## 1102 Universal Transmitter

November 2016

### Hardware Update

Figure 1: 1102 Universal Transmitter Housing

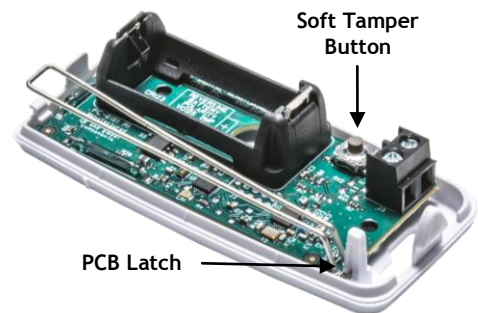
The 1102 case now features a streamlined plastic design that is easy to open and close. To open the case, press the button on the end of the 1102 and gently pull up on the transmitter cover. See Figure 1.

The 1102 no longer uses a spring to trigger the case tamper. The new design includes a built-in case tamper post which activates the soft tamper button on the PCB.

It also includes a PCB latch that allows installers to easily remove the PCB by pressing the latch with their thumb.
